## Addendum #2

December 29, 2009

Renovations to:  
7991 Columbus Pike  
Lewis Center, Ohio 43035

DCDD  
Renovations To:  
7991 Columbus Pike  
Lewis Center, Ohio 43035

## APPENDIX A

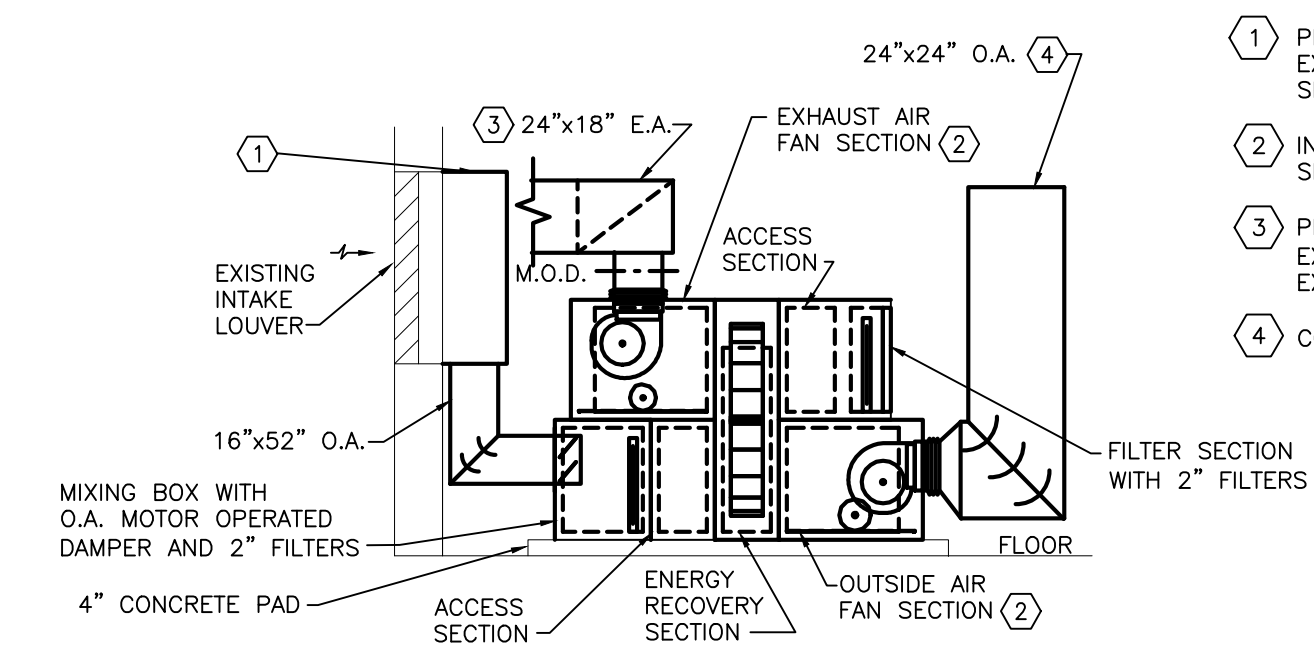
Sheet H0.0 shows the geo piping schematically only. See sheet H1.0B for exact location of pipes entering the building.  
For information concerning the test well see attached well log report Appendix "A" at the end of this addendum.

BASEMENT HVAC NEW WORK PLAN  
BASE BID "B"

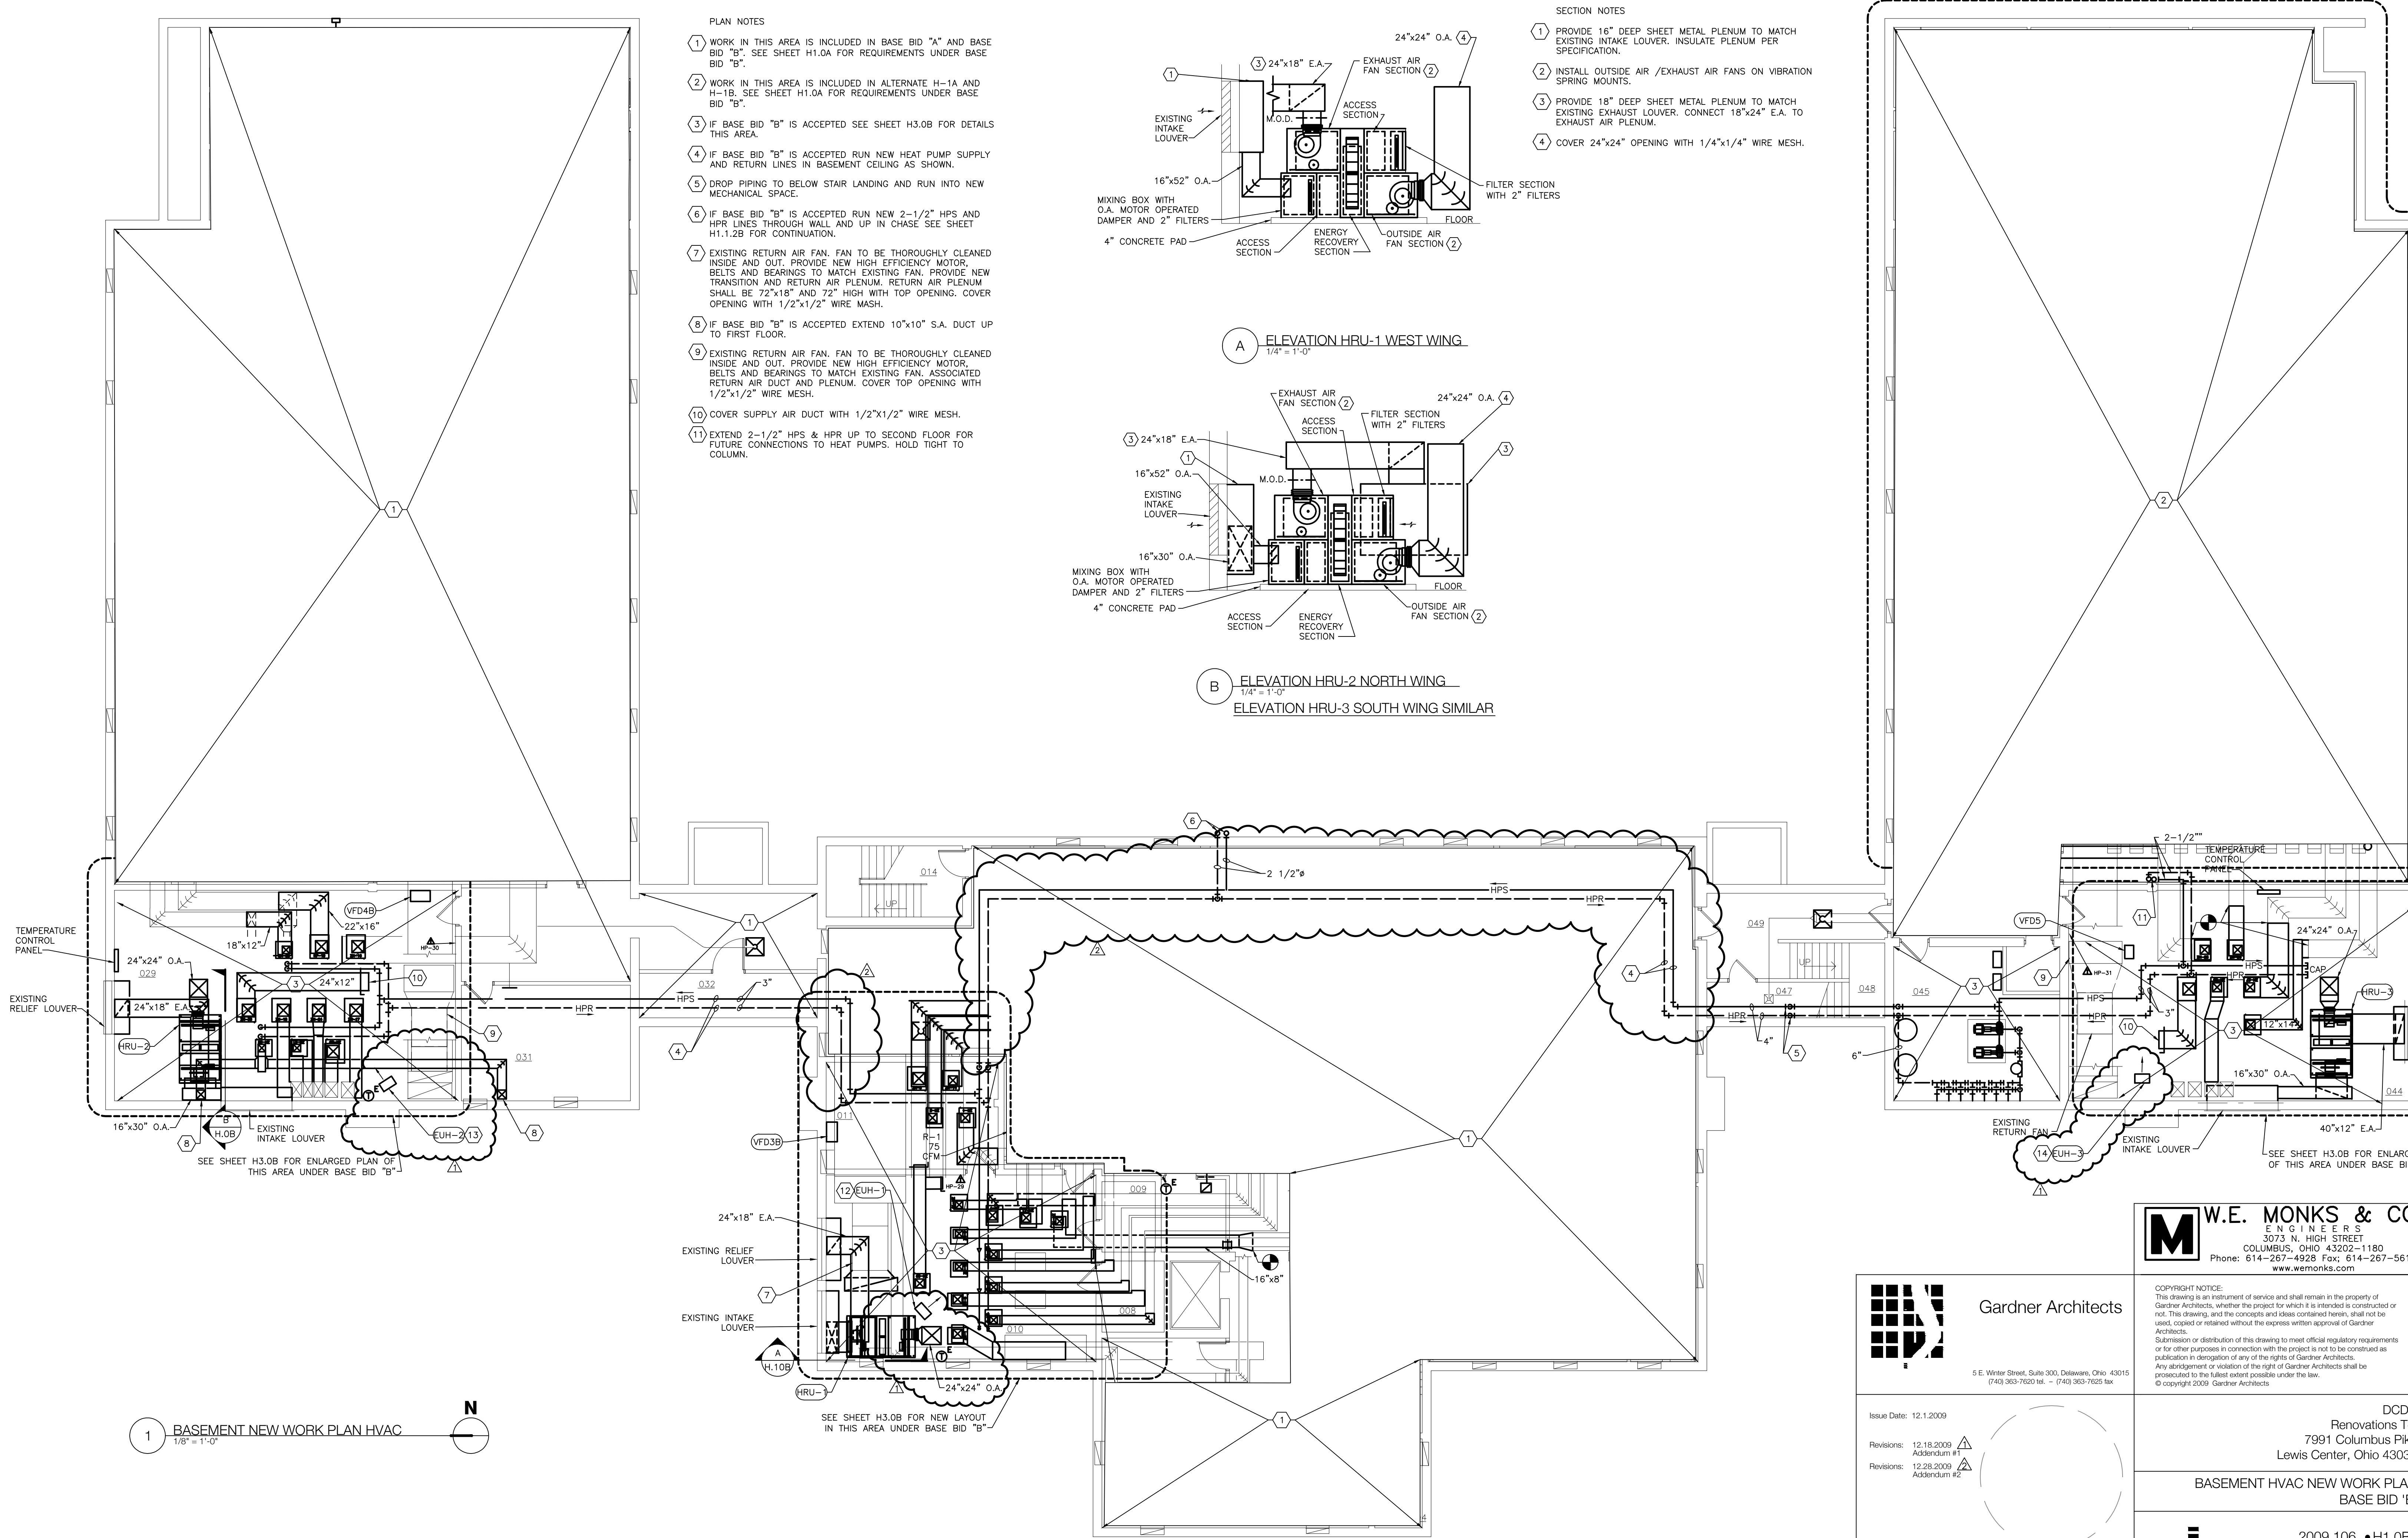
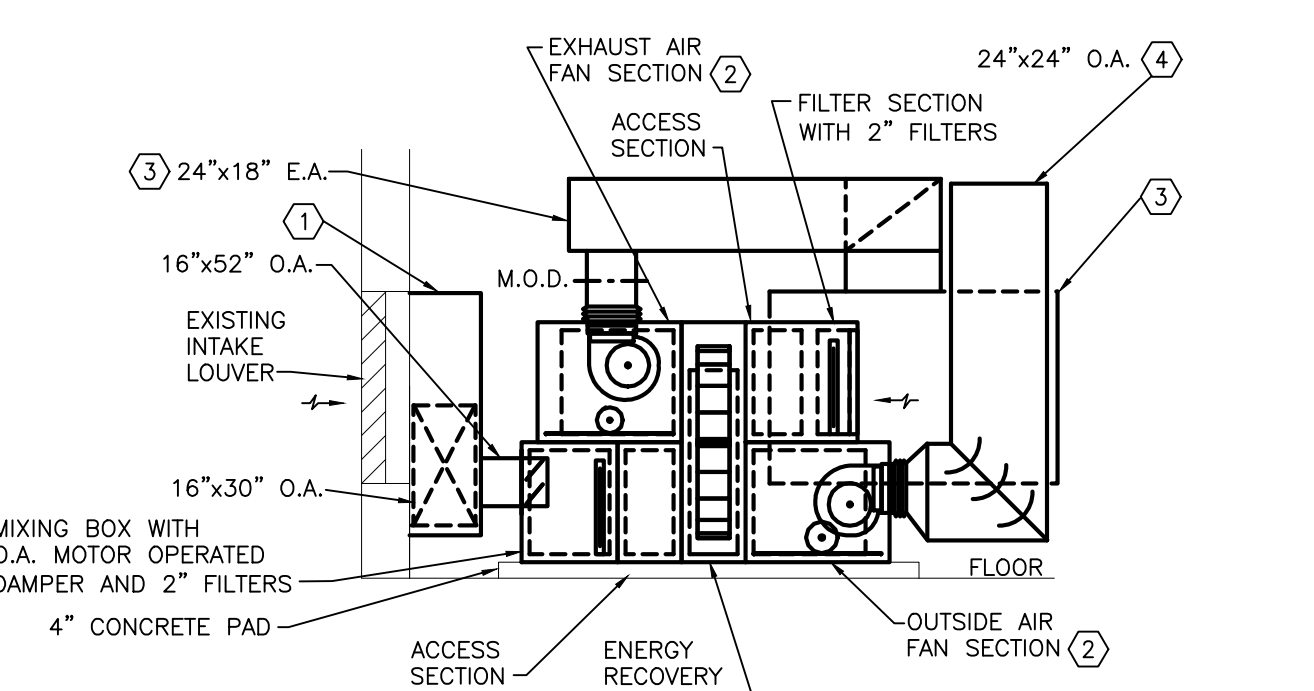
**VFD number on drawing H1.0B is VFD4B, and on H3.0B is VFD3B. Which is correct?**

Drawing Sheet H3.0B North Wing Mechanical Room change variable frequency drive for return fan to VFD4B. Drawing Sheet H1.0B is reissued in its entirety as part of Addendum #2.
